TRANSPORT AND TRAFFIC PLANNING ASSOCIATES

7 October 2025
Ref: 20352_Revision B

Proposed Greenwich Hospital Redevelopment

I have assessed the updated basement plans provided by Brickerton Masters (Appendix A)

REVISION: P30
DATE:
DRAWING No: DD-SW-0200
DRAWING TITLE: SITE LEVEL PLAN - LEVEL 1 (BASEMENT)
DRAWN: NAH CHECKED: SCALE: 1 : 500 @A1

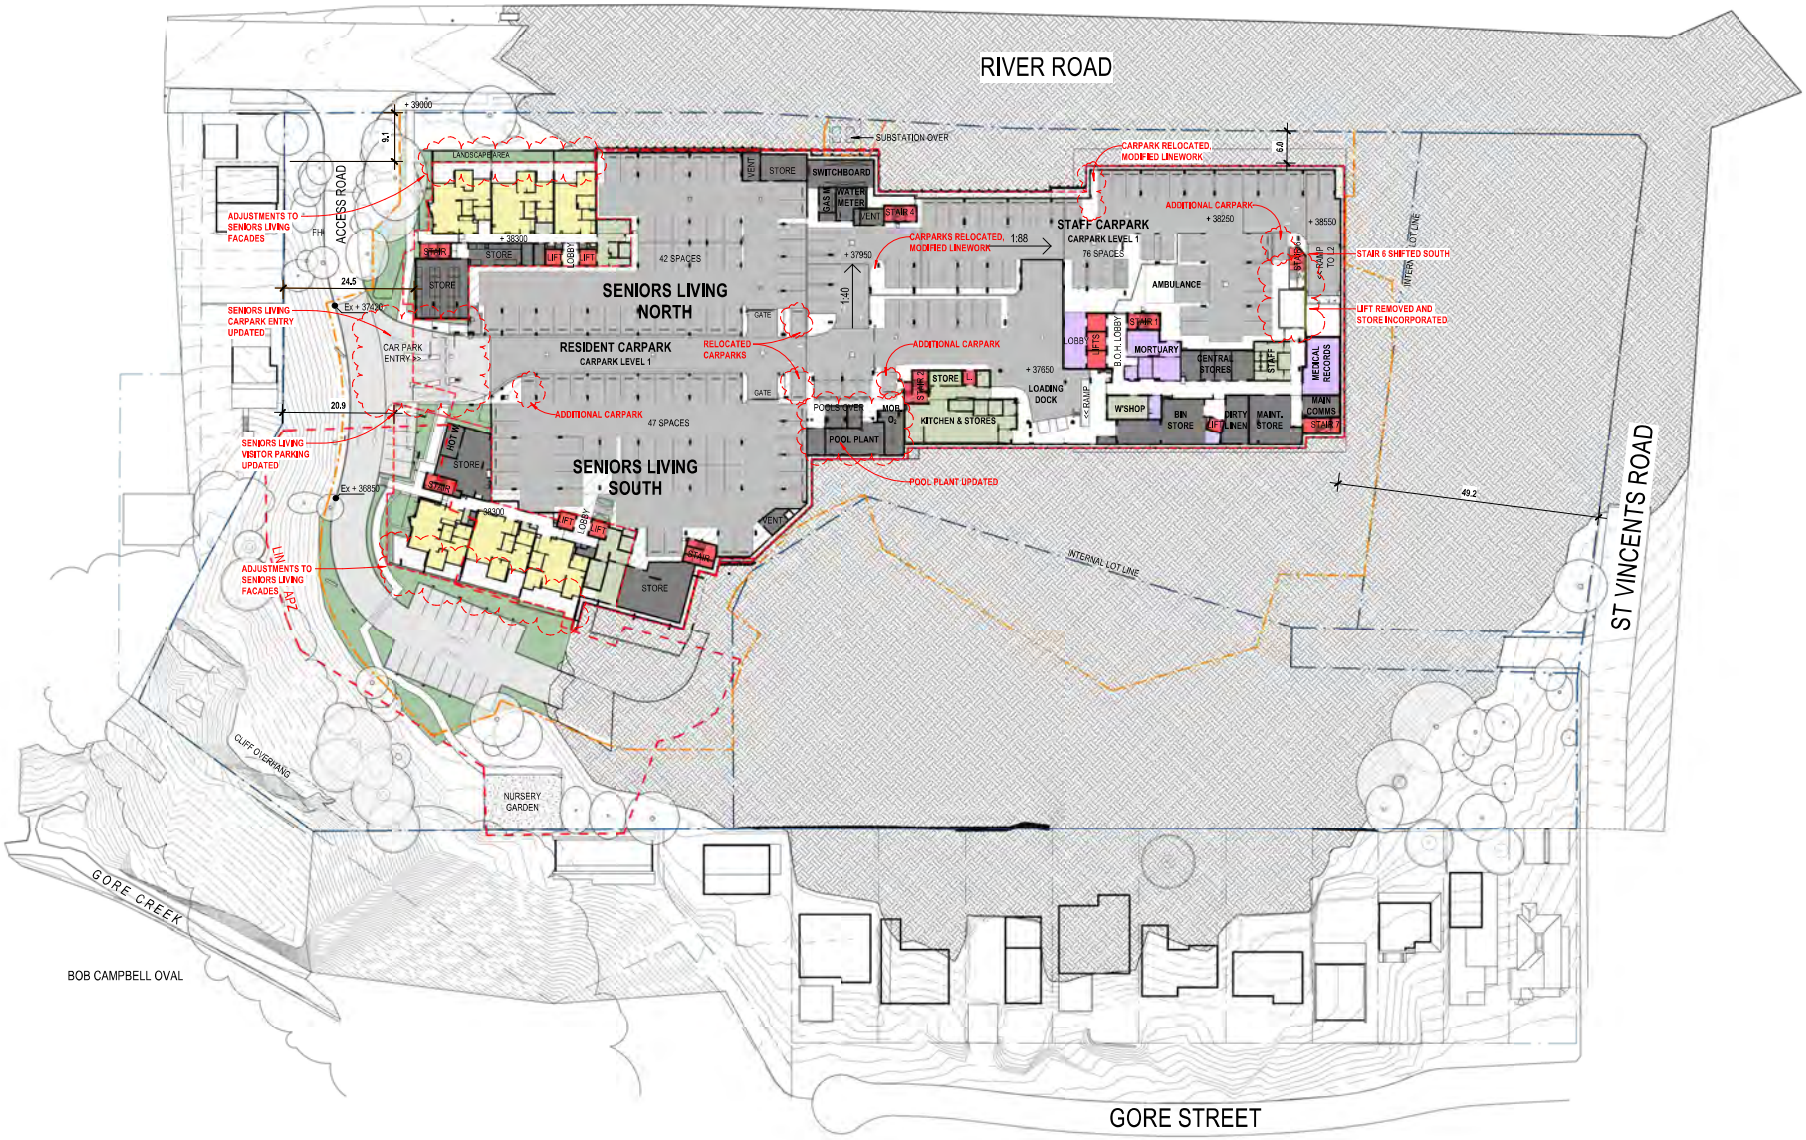
My assessment has regard for the design principles of the AS2890.1. It is my assessment that the car parking and circulation on the revised basement plans are compliant with AS2890.1. Turning path assessments showing satisfactory manoeuvres are attached to Appendix B and suggested linemarking and traffic controls are attached to Appendix C.
